Golden Gate Bridge & Highway District

Investigation of Criticism of Foundation by
DR. BAILEY WILLIS

Report of Building Committee

South Pier - Investigation of criticism
of foundation by Dr. Bailey Willis, Pro-
fessor Emeritus of Geology, Stanford
University.

FIG. 1

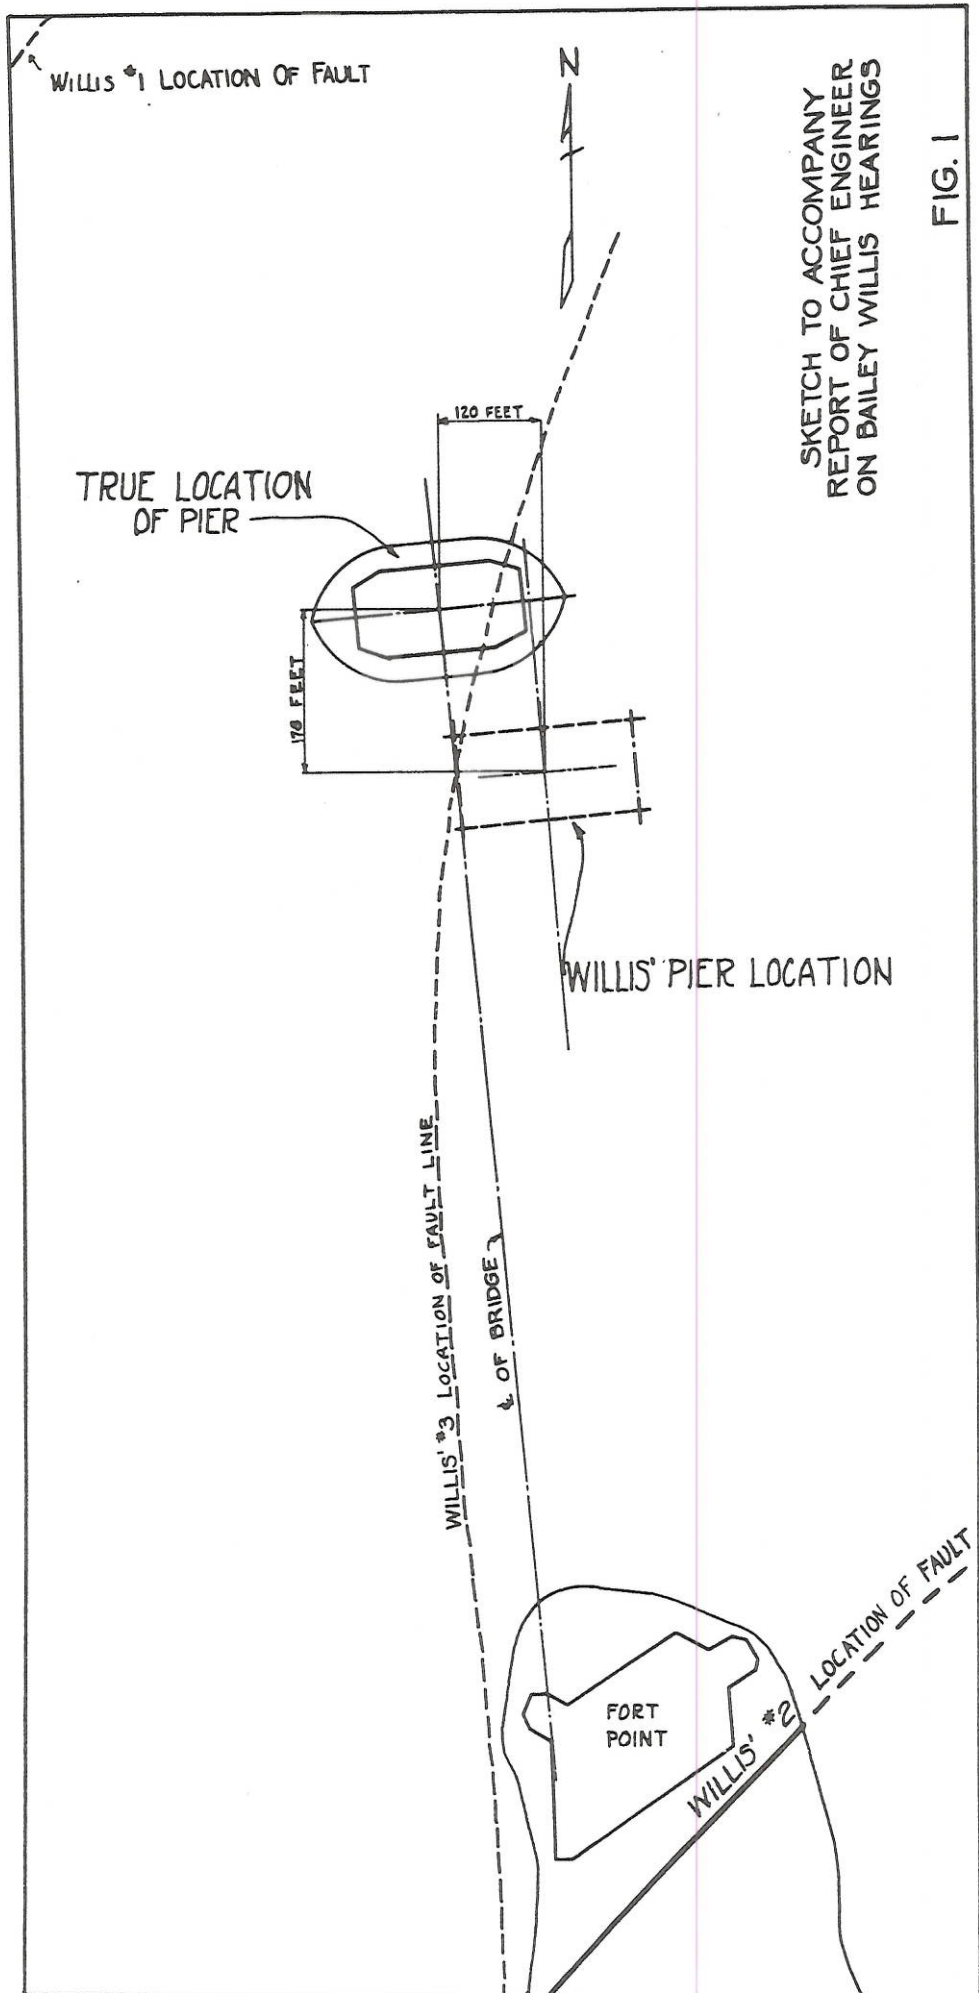
sandstone and the fault between the sandstone and the serpentine. These projections are upon an enlargement of a section of a sheet of the Coast and Geodetic Survey. (Exhibits 9, 9-a and 9-b.) The map as originally presented projected all these features and there was but one fault line. It was thereafter demonstrated that Professor Willis had made an error in location of the south pier, that he had located it by "general information", that he had placed the pier as near as he could on the diagram "not considering that for geological purposes that the exact location of the pier was a matter of very much consequence", and that he had found, as he had been told after introduction of the map, that the pier was located 178 feet north and 120 feet west of the location which he had shown. (Transcript 3, page 8.) Exhibit attached. (Fig. 1.)

The fault line projected on Professor Willis' original map would have passed directly through the south pier correctly located. When Professor Willis re-ramped the map he moved the fault line west and this represented the progress of his studies in the interval between September 28th and October 22nd which had also developed other faults which were delineated on the map showing the correct location of the pier. (Transcript 3, page 12.)

FIG. 3

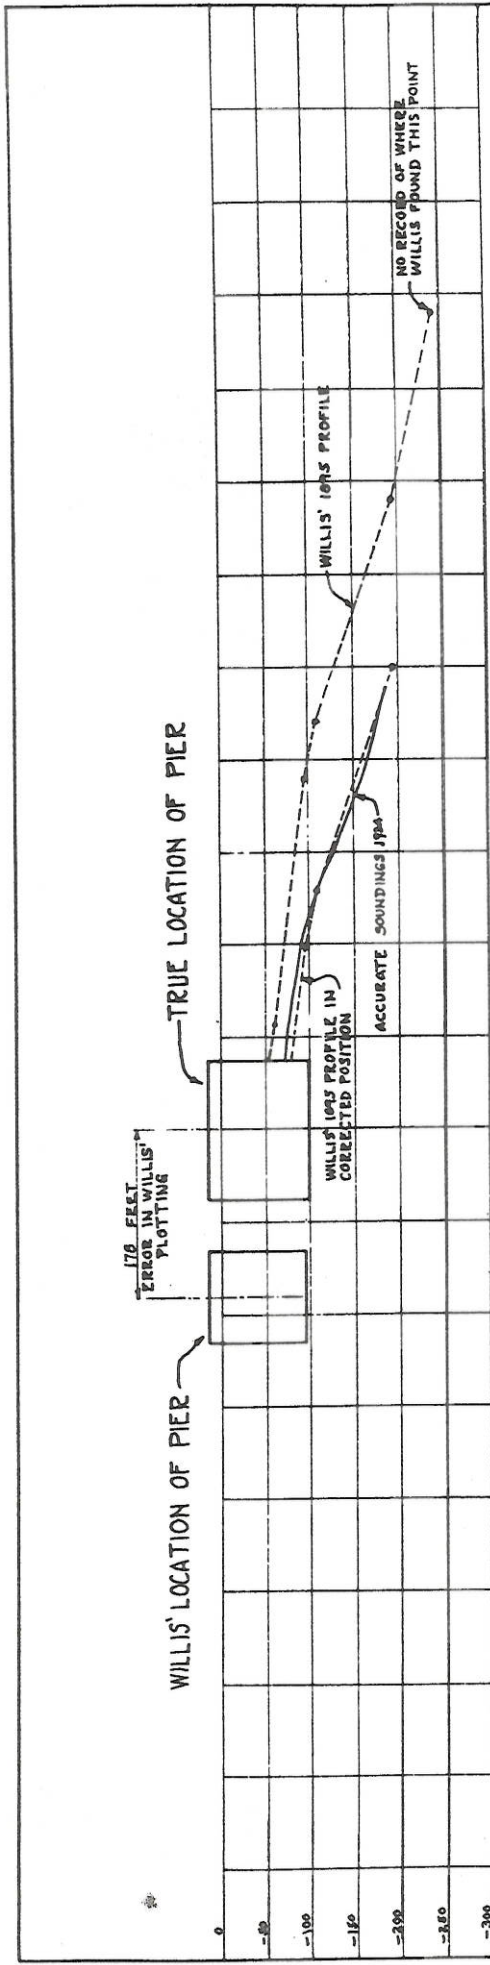
He also claimed that there was no error in his delineation of the north-west profile, but this does not accord with the checking of the District engineers. The misreading of the obscure numeral by the Professor, as the numerals related to fathoms, made a difference of 60 feet. (Transcript 3, page 62.) Exhibit attached. (Fig. 3)

Professor Willis replied, in answer to a question, that if the profile was identical, in that event his assumption there would be incorrect. (Transcript 3, page 67.)

SKETCH TO ACCOMPANY
 REPORT OF CHIEF ENGINEER
 ON BAILEY WILLIS HEARINGS
 FIG. 2

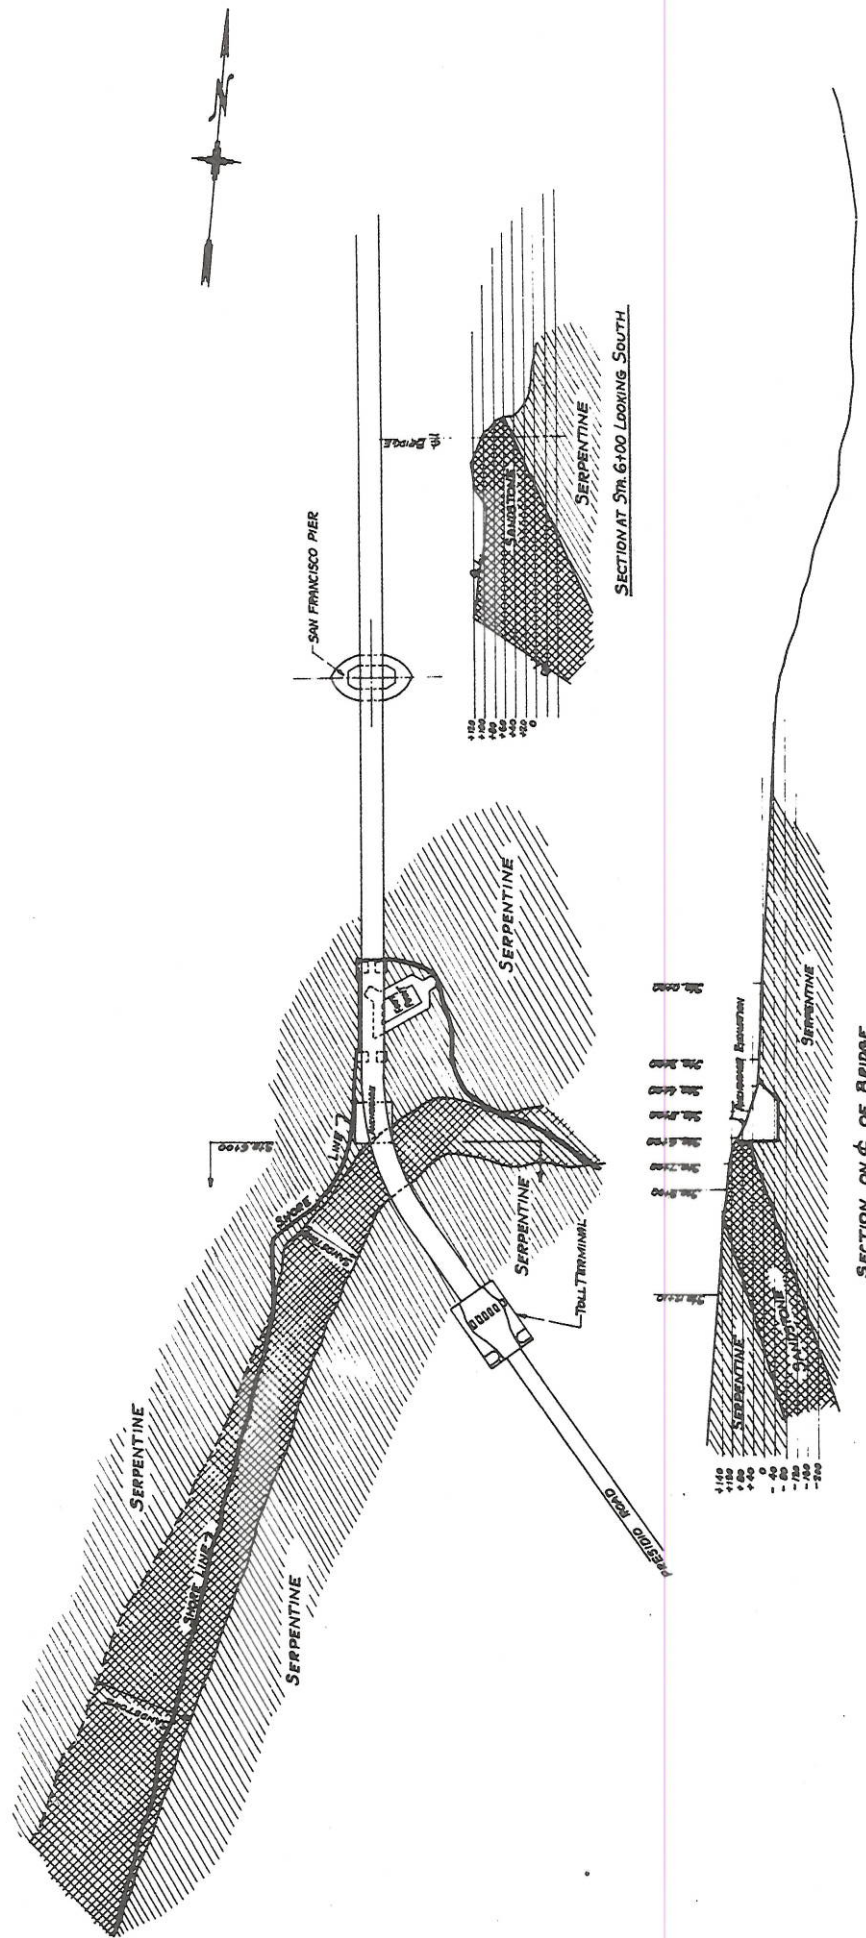
There is sandstone which is exposed on the cliff and in the excavation

south of the anchorage. This sand-stone strikes east and southeast from the anchorage and slopes south. This layer could not, therefore, underlie the pier. Professor Willis had not seen the exposure in the excavation for the anchorage. (Transcript 2, page 27.) After this fact was developed Professor Willis claimed that there was a serpentine intrusion and that there is a sand-stone underneath the serpentine upon which the anchorage, the Fort and the pylons rest and which underlies the south pier. Exhibit attached. (Fig. 3.)

He alludes to islets skirting the shore which he claims are sand-stone. There are two very small islets southwest of the anchorage, the most northerly of the series of islets, which are sand-stone. The Professor exhibited a photograph sighting from the shore line through these northerly islets to a point west of the south pier site and bases his claim that the sandstone extends in the same general line upon the existence of these islets. The fact is that a plan of the islets and a photograph taken in the opposite direction demonstrate that there is a general curve toward the shore which, projected, would coincide with the strike of the exposed sandstone.

SKETCH TO ACCOMPANY
 REPORT OF CHIEF ENGINEER
 ON BAILEY WILLIS HEARINGS
 FIG. 4

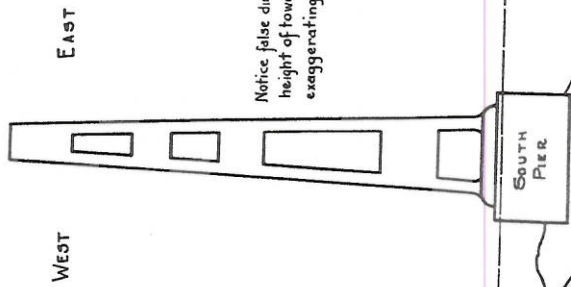
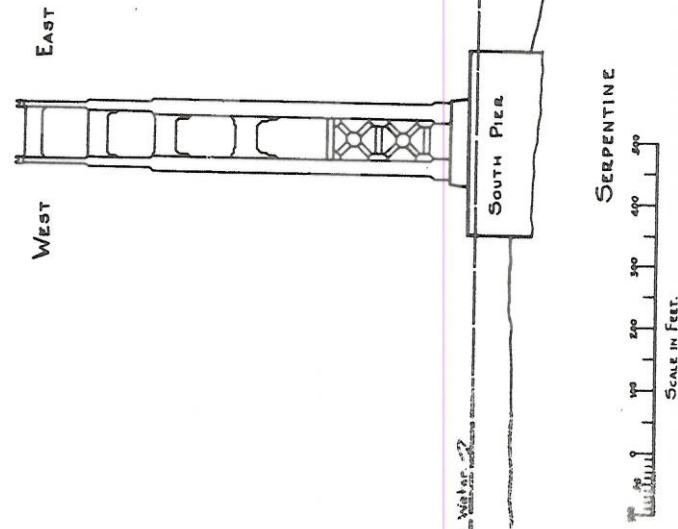
Professor Willis projected this underlying sandstone in an east-west section through the south pier in an article appearing in the Argonaut, October 19th, pending the hearing. It developed at the hearing, October 22nd, that the section was erroneous. This section was published in the Argonaut as an ocular demonstration that the south pier would rest on serpentine superimposed upon a slippery fault over sandstone. It was not only erroneous as to the depth of the water, but exaggerated the slope. If the pier was drawn to scale, the sandstone should be exposed within approximately 30 feet below the westerly end of the pier and within approximately 75 feet of the easterly end of the pier.

He indicated the depth of the channel to be 340 feet in this section, when, as a matter of fact, it is 241 feet, being a difference of approximately 100 feet. Exhibit attached. (Fig. 4)

Notice false dimensions, in depth and location of channel, height of tower, and size of pier for the purpose of exaggerating alleged instability.

THIS MODEL, BY PROFESSOR WILLIS, IS ON A DISTORTED SCALE. ANY SOUNDINGS USED IN ITS MAKING WERE TAKEN FROM COAST AND GEODETIC CHARTS. FROM SUCH SOUNDINGS IT IS IMPOSSIBLE TO DERIVE SUCH DETAIL AS SHOWN HERE.

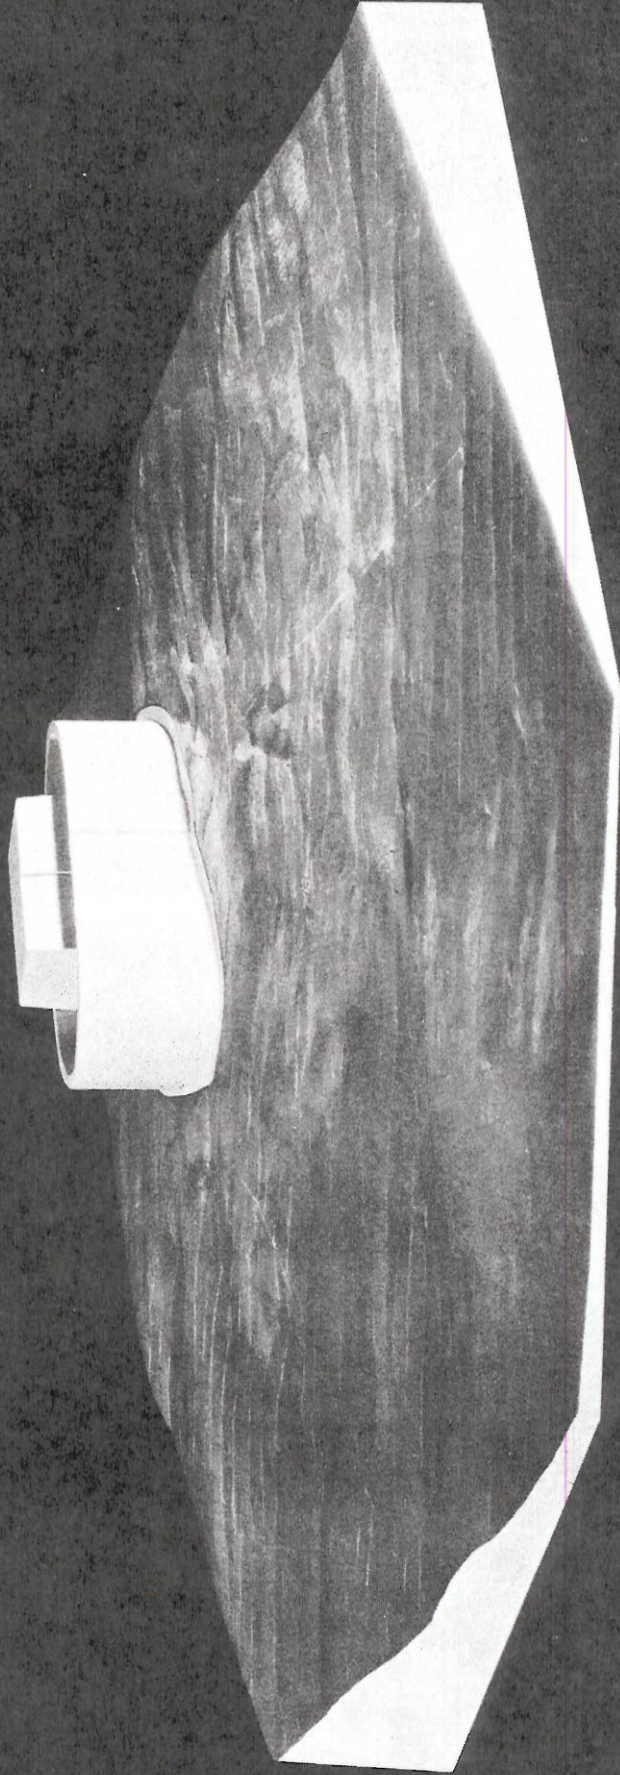
Professor Willis also exhibited a model of the formation on which the pier is located, the design being based upon Coast and Geodetic Survey maps (transcript 3, page 44), but with a peculiarity that the vertical was exaggerated 5 to 1. (Transcript 2, page 42.) This would have the effect of increasing the slope, and, unless one may visualize the actual slope with the knowledge of an engineer, is deceptive. It is difficult to conceive the purpose, particularly if it were intended for information of the public. It not only exaggerated the slopes, but exaggerated the so-called gulleys and canyons. A print was also reproduced in the Argonaut. The south pier was projected thereon incorrectly and had the appearance of being perilously near the edge of a steep bluff. That was the effect of exaggerating the vertical. (Transcript 2, page 45.)

THIS MODEL IS AN EXACT REPRODUCTION ON A NATURAL SCALE OF THE SAN FRANCISCO PIER AND FENDER AND ROCK SURFACE UPON WHICH THEY ARE BASED. PIER AND FENDER MADE FROM CONTRACT PLANS. THE RELIEF MAP FROM THE 600 SOUNDINGS TAKEN BY DISTRICT FORCES.
